Addendum

Florida Gateway College
New Building 102 – STEM Two
FGC ITB # ST-24-01-06
Lake City, Florida

02

May 14, 2024

POWER & SYSTEMS PLAN - SECOND FLOOR
 SCALE: 3/16" = 1'-0"

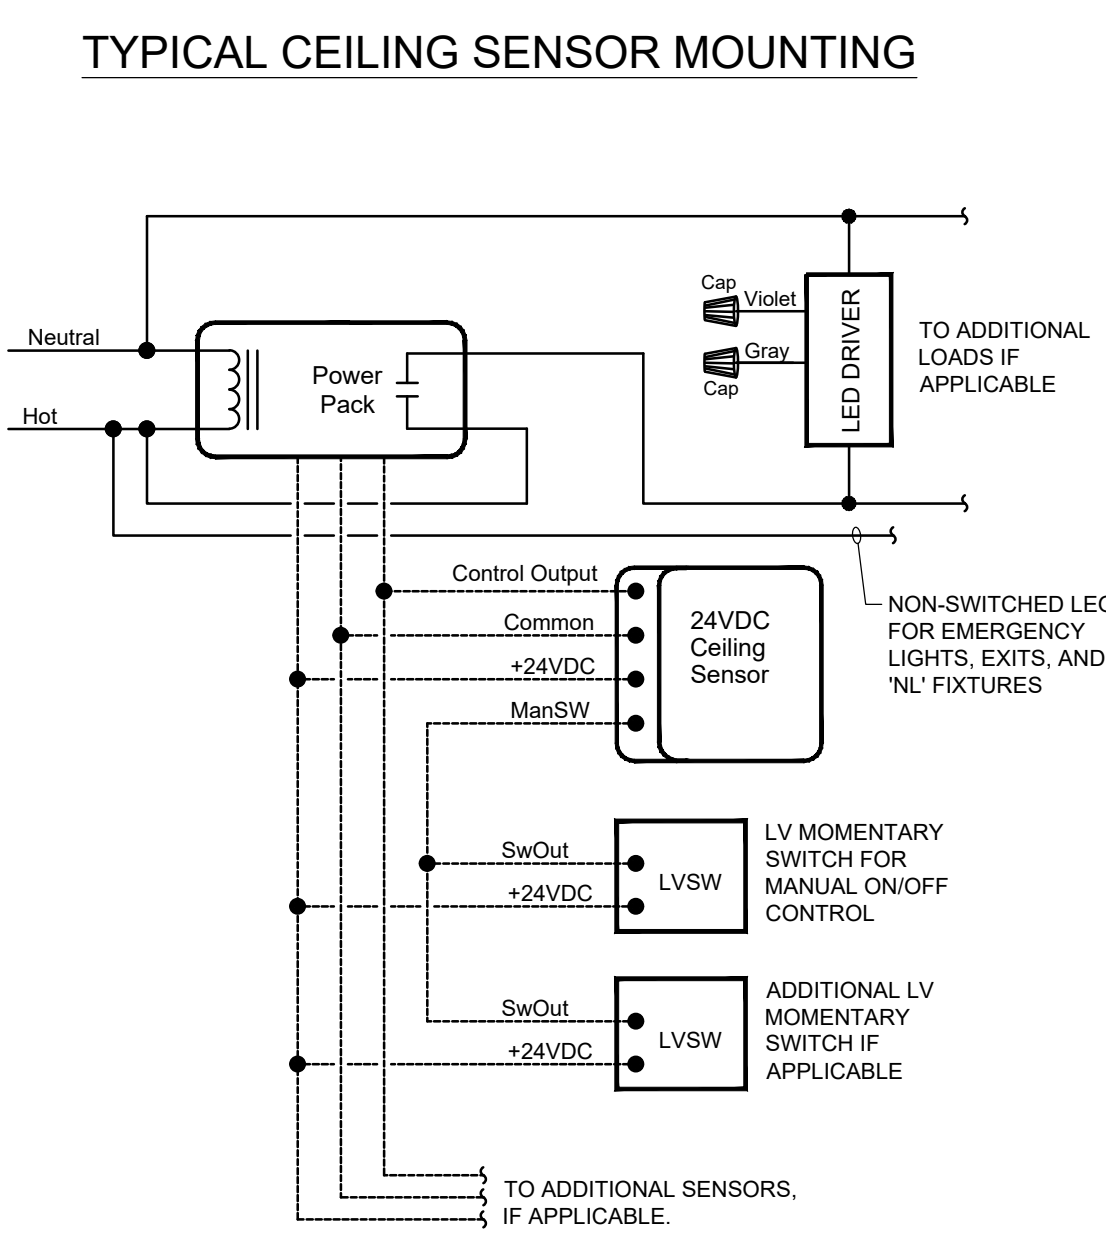
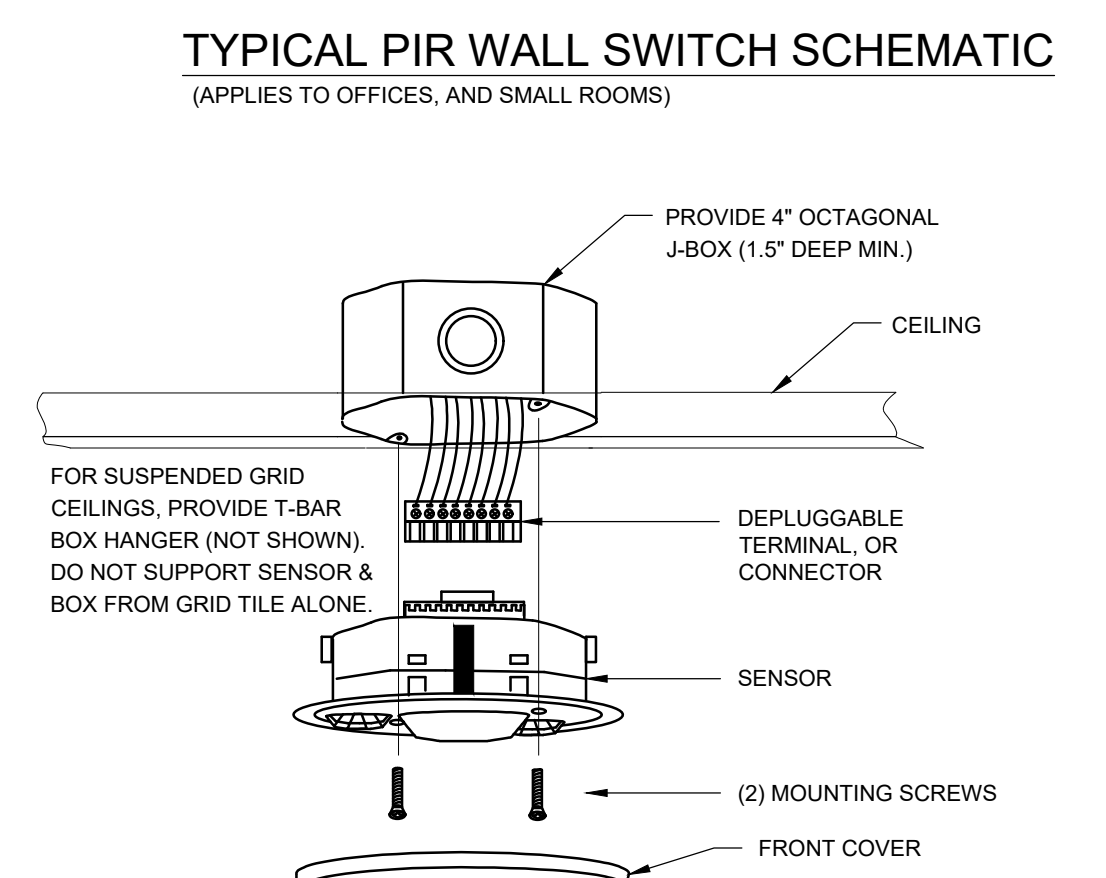
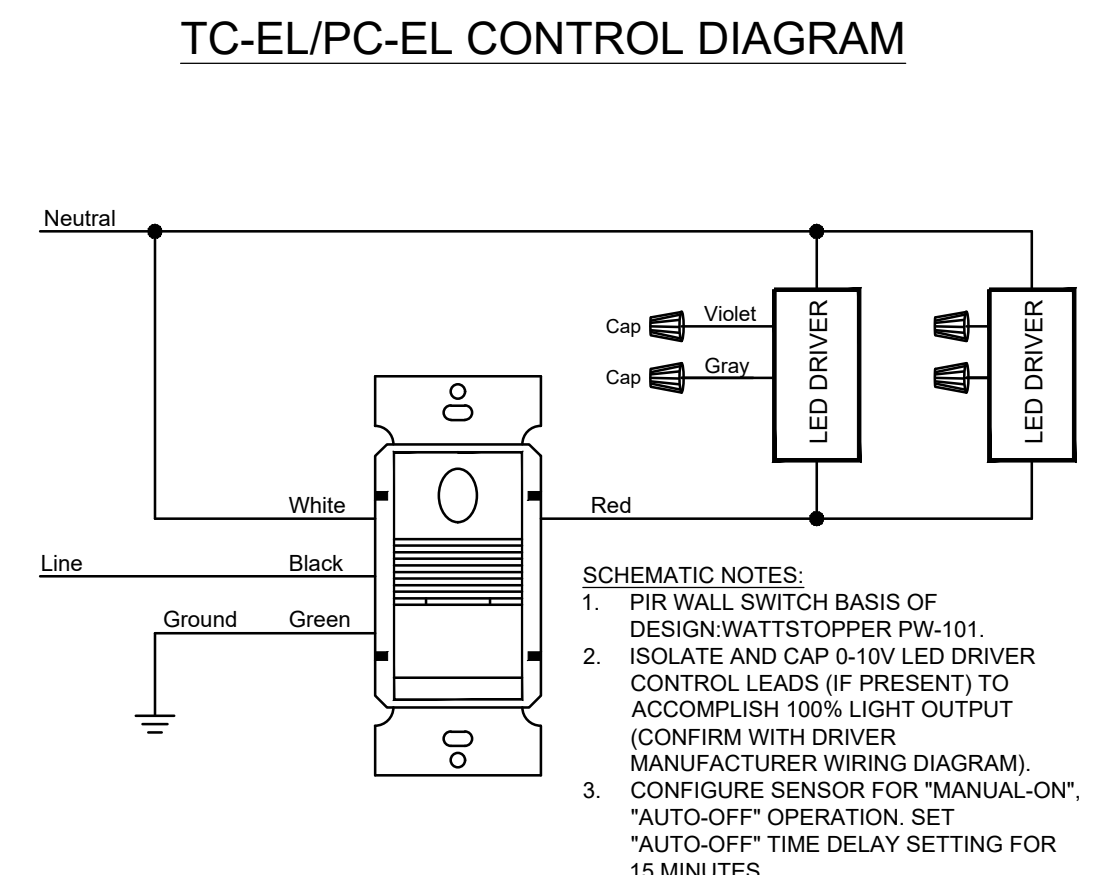
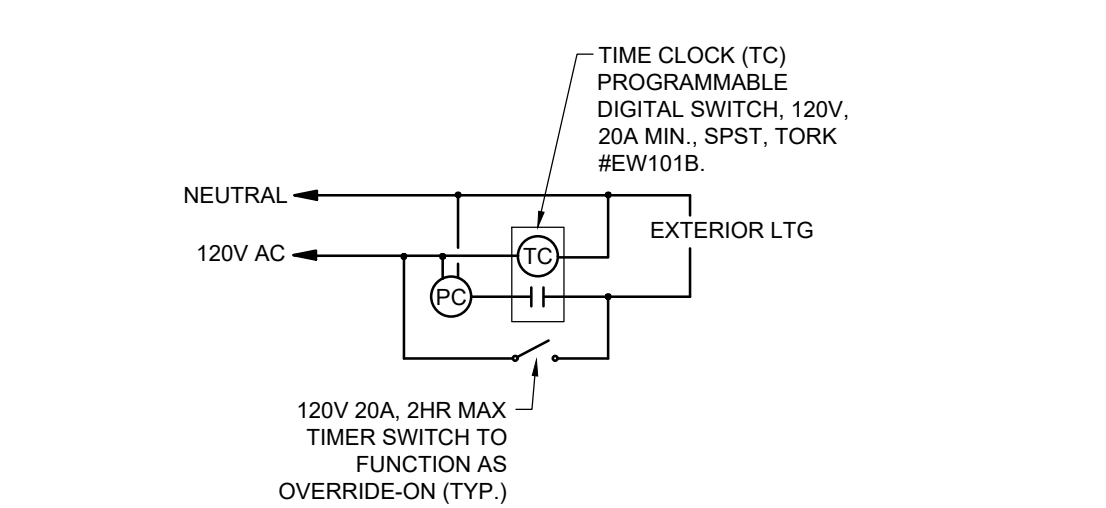
27. **DRAWINGS, SHEET E201 - LIGHTING PLAN - FIRST FLOOR, E202 - LIGHTING PLAN - SECOND FLOOR, E211 - POWER AND SYSTEMS PLAN - FIRST FLOOR AND E212 - POWER AND SYSTEMS PLAN - SECOND FLOOR:** Refer to the attached reissued Sheets. Added notes regarding location of boxes with respect to hard ceiling. Added some circuiting arcs which did not plot on original Drawings.

30. **DRAWINGS, SHEET E211 - POWER AND SYSTEMS PLAN - FIRST FLOOR AND E212 – POWER AND SYSTEMS PLAN – SECOND FLOOR:** Refer to the attached reissued Sheets. Security camera locations were added to plans. Contractor shall provide rough-in and CAT6 POE (power over Ethernet) cable for each location; camera will be provided by the Owner's security vendor.

TELECOM RISER DIAGRAM

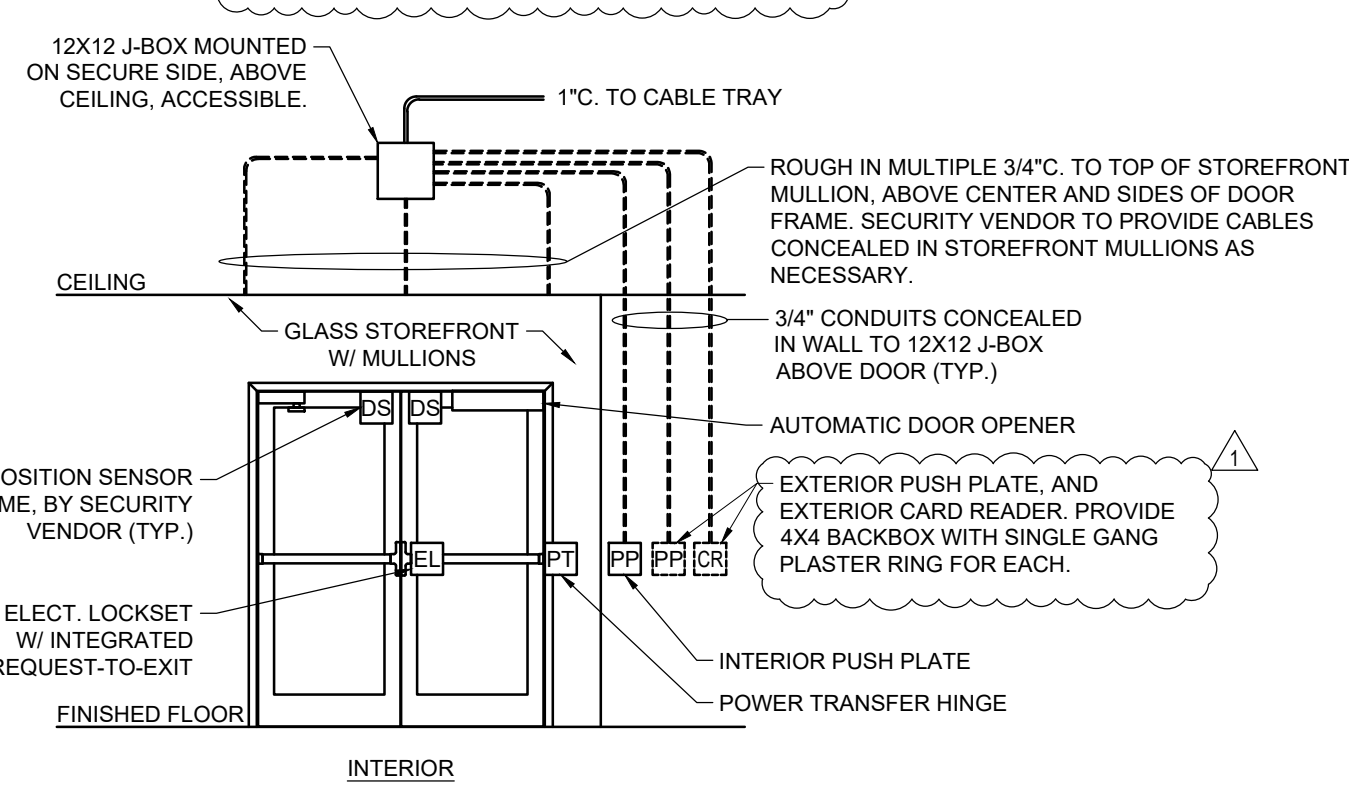
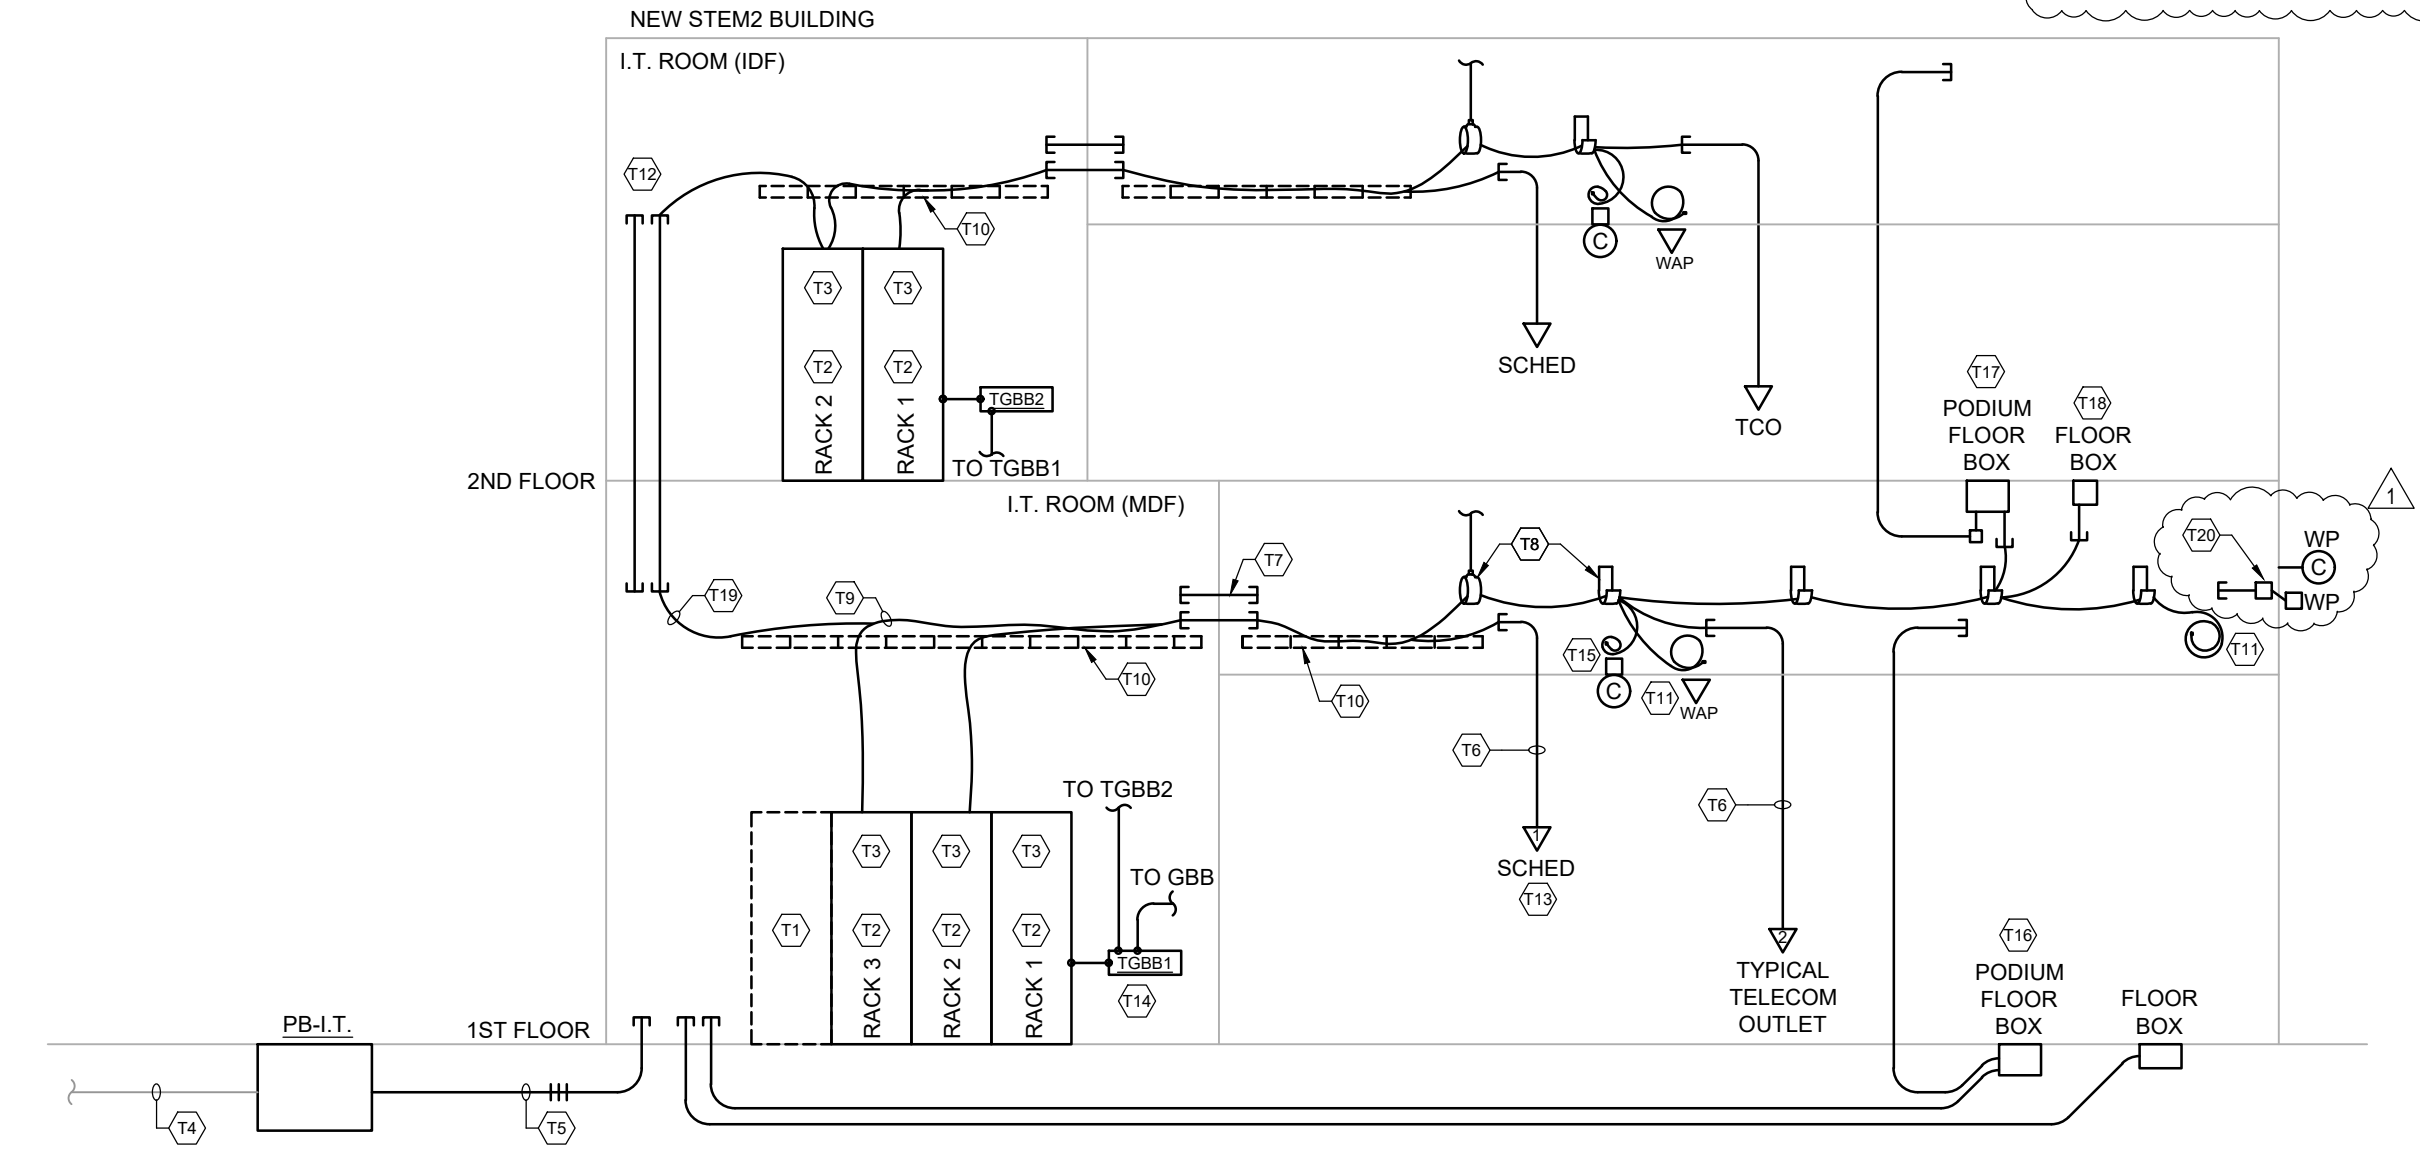
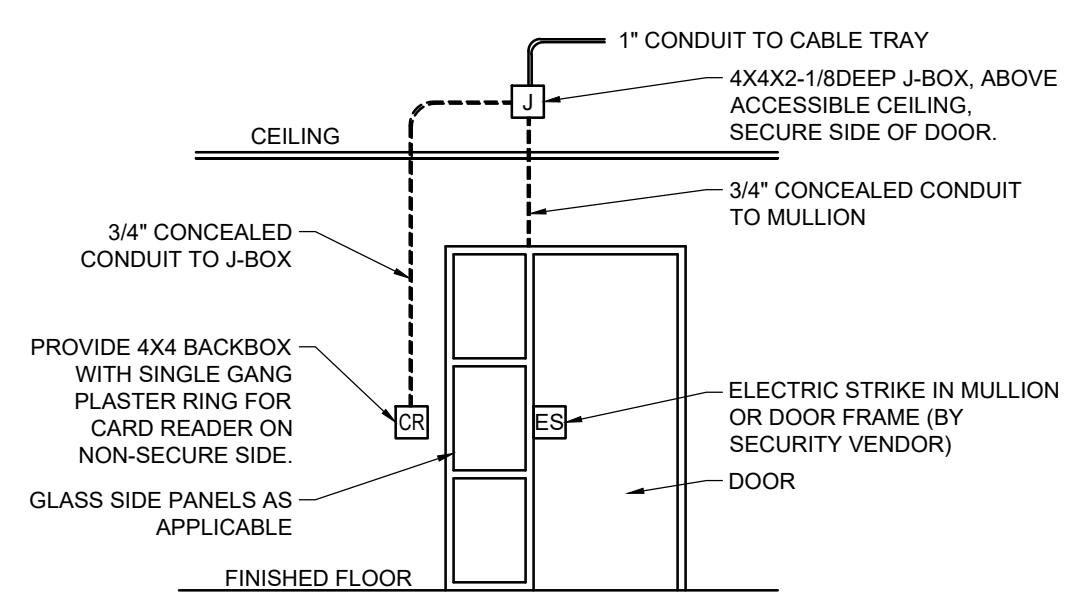
32. **DRAWINGS, SHEET E701 – SYSTEMS RISER AND DETAILS:** Refer to the attached reissued Sheet. PACS details and telecom riser diagram were revised, to clarify general contractor versus security vendor scope.
